City of Alexandria, Virginia

MEMORANDUM

SUBJECT:UPDATE MEMO ON 515 NORTH WASHINGTON STREET
(THE COTTON FACTORY)BAR CASE # 2014-0208 and 2014-0209

Figure 1. PREVIOUS Submission to BAR on July 16, 2014.

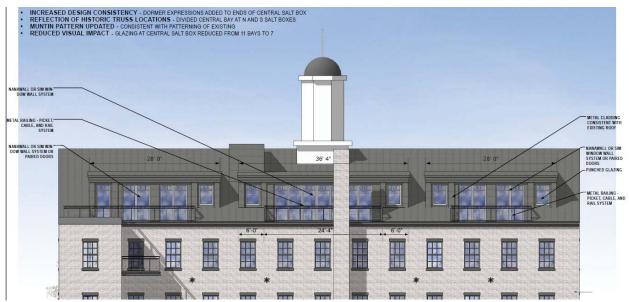
The applicant's current submission includes three dormer options. The first option, Option 1, reflects the original dormer proposal presented to the Board on July 16, 2014 which included three larger, modern shed dormers with balconies and NanaWall windows/doors. Based on the Board's comments, the applicant has studied and prepared two design alternatives, both of which

Staff supports the changes in both options that result in less overall visual mass and a smaller center balcony. Staff also supports the reduction in the continuous NanaWall on the end dormers. While Option B features a more traditional dormer expression with the use of individual pedimented dormers, it represents a modern interpretation of a traditional dormer form as it uses the appearance of individual dormers to mask the proposed shed dormer, much as the existing rear dormers do, however using a modern light configuration. While both Option A and Option B are generally acceptable to staff, the preference is for Option A as it will be less visually obvious and will recede more into the overall roof form, allowing the historic building mass and form to take precedence. Option B, although it has subtle distinctions from historic dormers, has more of an appearance of attempting to replicate a historic form with the series of Colonial Revival pedimented dormers. Staff prefers the differentiation and subservience of Option A.

- 1. Documentation of the historic roof framing system and a final report shall be deposited at the Local History section of the Alexandria Library as well as the Department of Planning & Zoning; and
- 2. Option A be the selected option with final details regarding window and railing specifications to be approved by BAR staff as part of the building permit review process.

Figure 2. CURRENT Submission, Option A.

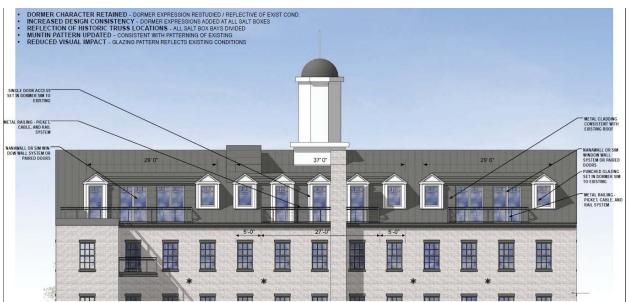
are approximately the same overall size but have smaller balconies and less visual mass by converting some doors to smaller window dormers. Both also show the end dormers to have two pairs of French doors separated by a pronounced mullion rather than a continuous NanaWall, as previously proposed. The light configuration was revised to reflect the smaller muntin pattern on the historic building. Option A features the modern approach but with a change to the center dormer to convert doors on the ends to windows –an area about six feet wide at each end—as well as reducing the size of the balcony. The dormer walls and trim will be clad in the same material as the roof to further make these elements recede. Option B draws its inspiration from the existing dormer design which appears as individual pedimented dormers with traditional Colonial Revival white trim. However, the dormer windows in this proposal do not feature a traditional light configuration. The end dormers each have two pedimented end dormers and the center dormer has five pedimented dormers within the overall shed dormer.

RUSS CONDITIONS

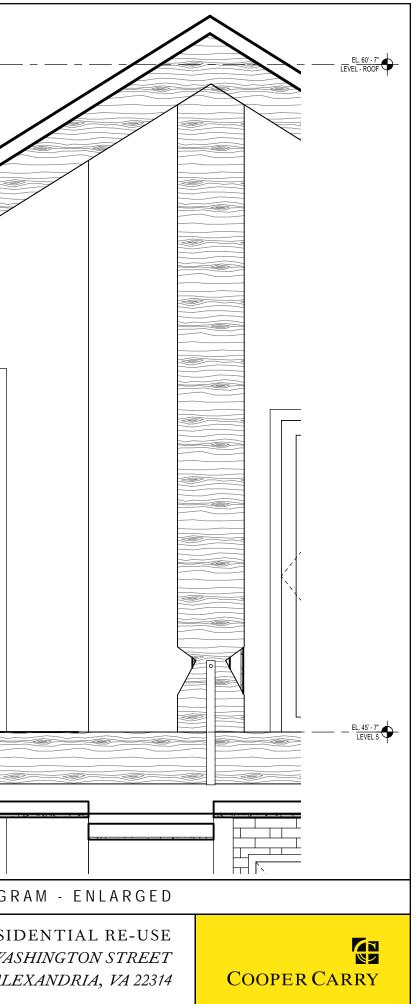
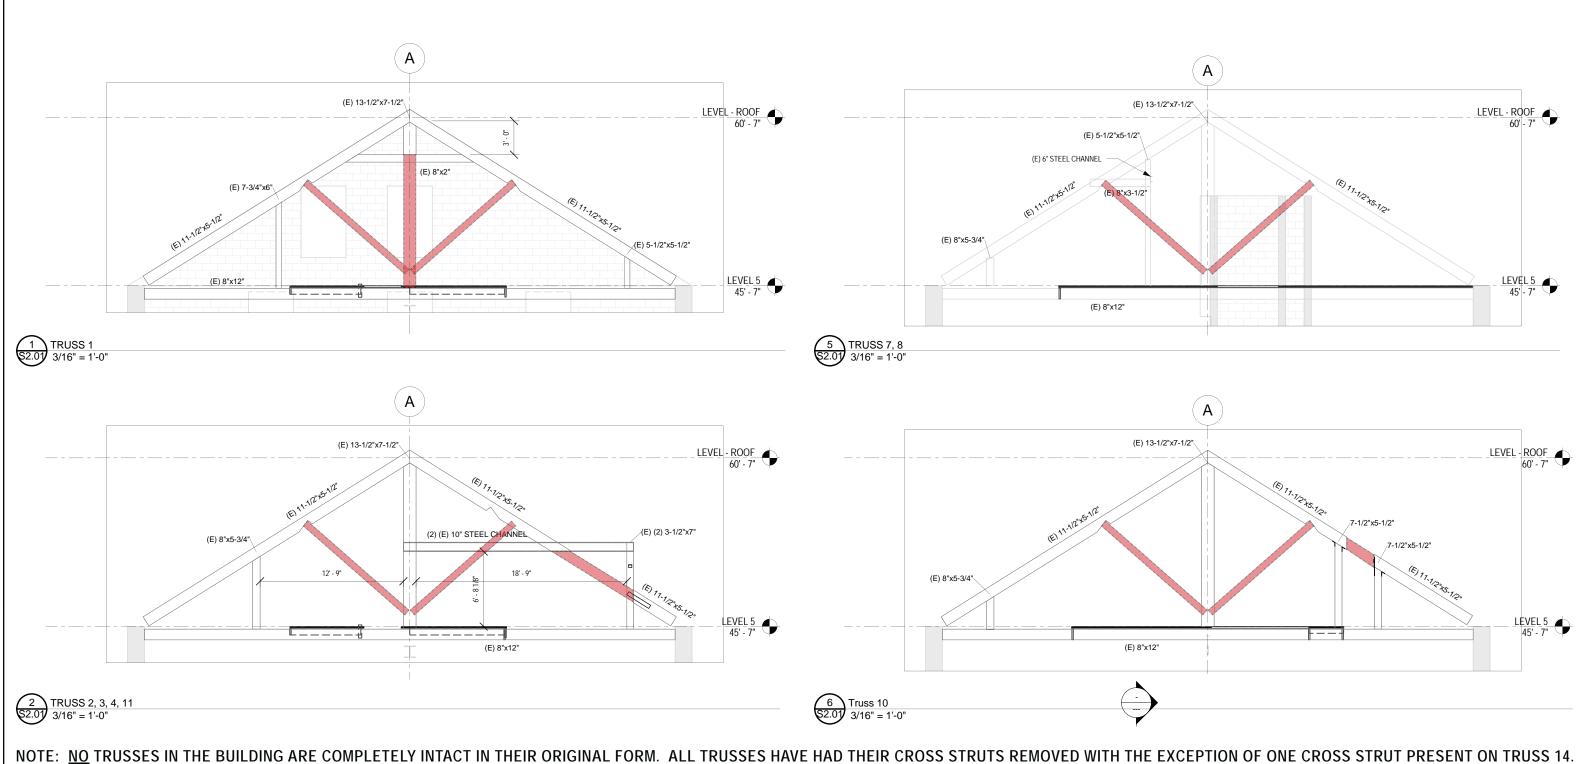
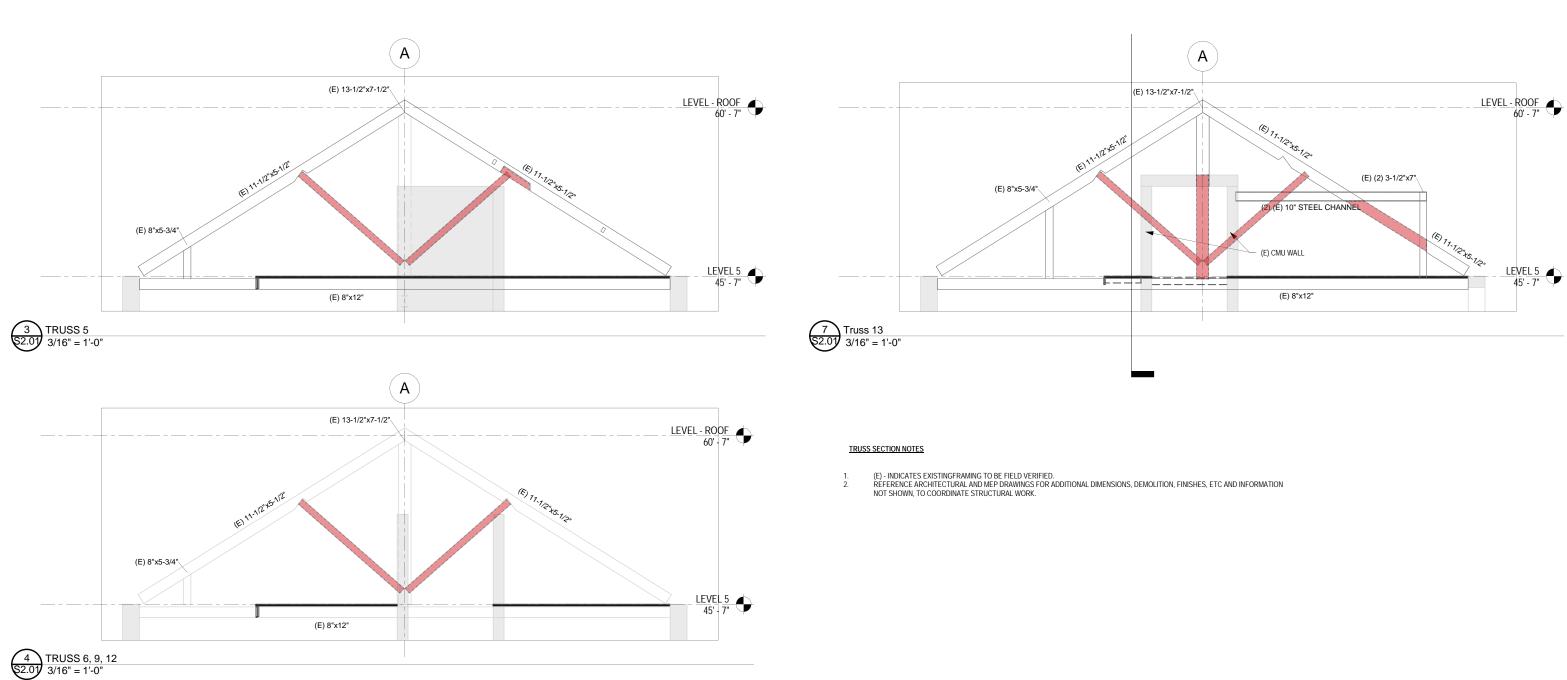
The applicant's current proposal has not reduced the amount of demolition and alteration to the historic roof trusses. As mentioned in the previous report, nine out of 14 trusses currently remain intact and in relatively good condition. Because the three center dormers are singletons, there remain four completely intact roof beams in this portion of the roof. Four out of fourteen trusses will remain intact or repaired to the original condition in this proposal. The applicant plans to alter the top chords of the existing trusses such that, by through the top chord, it would be rotated at an angle that would visually support the new shed dormer roof. While such a scheme represents adaptive reuse of historic building material on the site, it is not sound preservation as it misrepresents the construction technology of the original roof framing system and features much larger elements than would be necessary for a simple shed dormer. However, reusing the heavy timber roof trusses on site is preferable to disposing of these remaining historic elements.

On the one hand, staff believes that a more limited program that retains the heavy timber trusses in their original configuration is the preferred preservation approach. However, as this building has minimal historic fabric intact beyond the exterior walls, and the roof structure has already been significantly altered during two separate construction efforts in the past, the current roof structure is not unadulterated. While staff would prefer a scheme that retained the remaining center trusses, it is understood that doing so makes for an unuseable adjacent space. Therefore, staff can support the proposed roof truss alterations with the condition that the applicant document and detail the historic roof framing system to the satisfaction of staff and provide a copy of the documentation to the Department of Planning & Zoning and the Local History Collection of the Alexandria Library.
